HANFORD FEDERAL FACILITY AGREEMENT AND CONSENT ORDER CHANGE CONTROL FORM:
REDESIGNATION OF THE 200-ZP-1 AND 200-ZP-2 OPERABLE UNITS (OUs) AND
REDEFINITION OF THE 200 WEST AREA GROUNDWATER OUs

Change Number C-93-04	Federal Facility Agreement and Consent Order Change Control Form Do not use blue ink. Type or print using black ink.	Date 3/21/1993
Originator P. M. Pak		Phone 6-4798
Class of Change <input type="checkbox"/> I - Signatories <input checked="" type="checkbox"/> II - Project Manager <input type="checkbox"/> III - Unit Manager		
Change Title REDEFINITION OF THE 200-ZP-1 GROUNDWATER OPERABLE UNIT AND REASSIGNMENT OF ASSOCIATED GROUNDWATER INVESTIGATIONS, WASTE MANAGEMENT UNITS, AND UNPLANNED RELEASES.		
Description/Justification of Change This change request C-93-04 will implement the recommendations of the 200 West Groundwater Aggregate Area Management Study Report (AAMSR) for the definition of two groundwater operable units in the 200 West Area. The first groundwater operable unit is 200-UP-1, defined in TPA change request M-12-92-1 authorized in June 1992. The second groundwater operable unit will be 200-ZP-1, which will be formally established with approval of TPA change

Water Table Map with Recommended Groundwater Operable Units for the 200 West Area

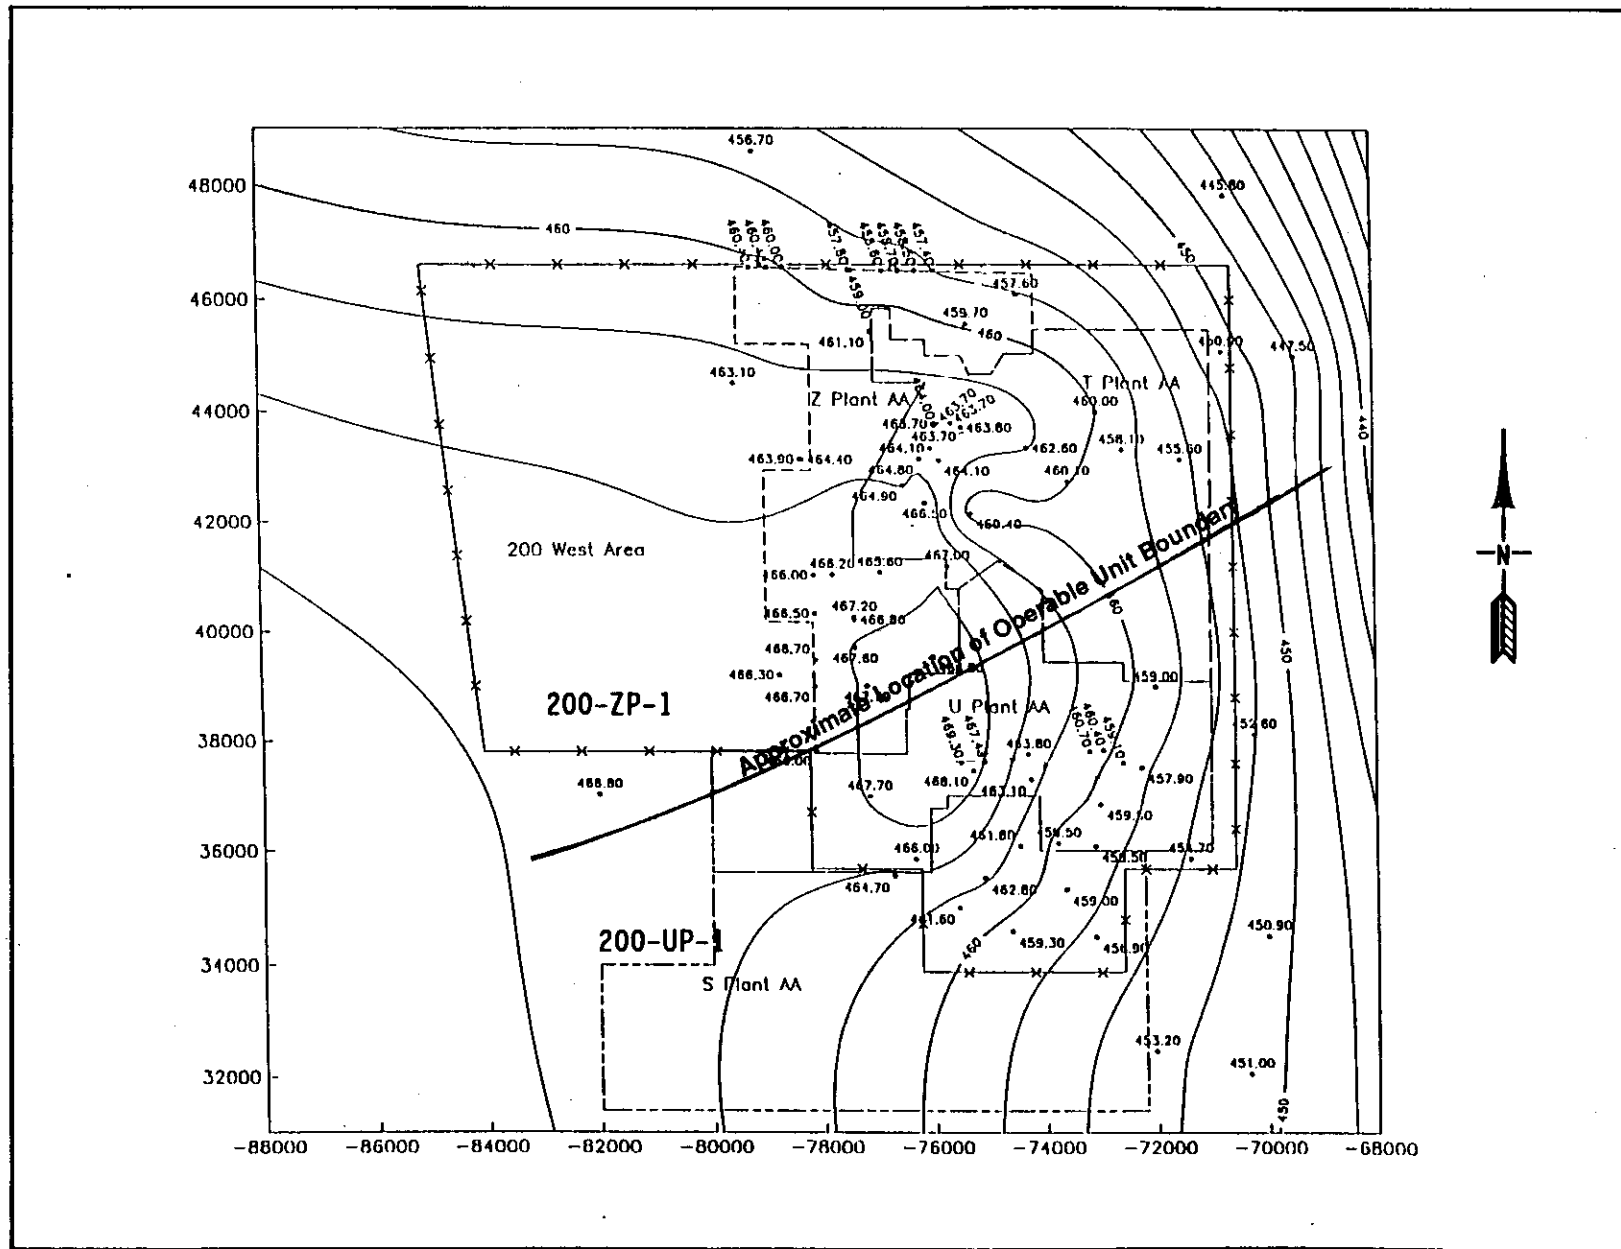
These two groundwater operable units would be divided on the basis of the hydrologic flow system present under the aggregate area. Two parallel hydrologic regimes can be defined, both emanating from the groundwater mound found beneath the location of the former U Pond (216-U-10). Groundwater flow on the north and northeast sides of the mound generally flows north-northeast towards Gable Gap. Groundwater south and east of the mound generally flows east-southeast towards a point south of the 200 East Area. The distributions of the contaminant plumes in the 200 West Groundwater Aggregate Area reflect these flow conditions. Contaminant plumes in the one regime or the other generally do not mix. These two groundwater flow regimes can therefore be the basis of the two groundwater operable units. The line of their division runs approximately along the northern edge of the U Plant Source Aggregate Area (see attached figure), as derived from groundwater potentiometric maps and the extent of the various known plumes.

Because of the interrelations of the contaminant plumes in the 200 West Area, it is considered best to have a relatively small number of groundwater operable units. It is also important, however, to keep the size and complexity of groundwater operable units small enough so that each can handle all groundwater issues in that portion of the 200 West Area. It is believed that these considerations can best be addressed by redefining operable units to create two groundwater operable units.

1. All waste management units and unplanned releases listed under 200-ZP-1 shall be moved to 200-ZP-2, and 200-ZP-2 designated as unit category CPP.
2. Redesignate the 200-ZP-1 Operable Unit as a groundwater only operable unit which will address the groundwater beneath the 200-ZP-2, 200-TP-2, and 200-TP-4 Operable Units. 200-ZP-1 should be designated as unit category CPP and given a priority of A.
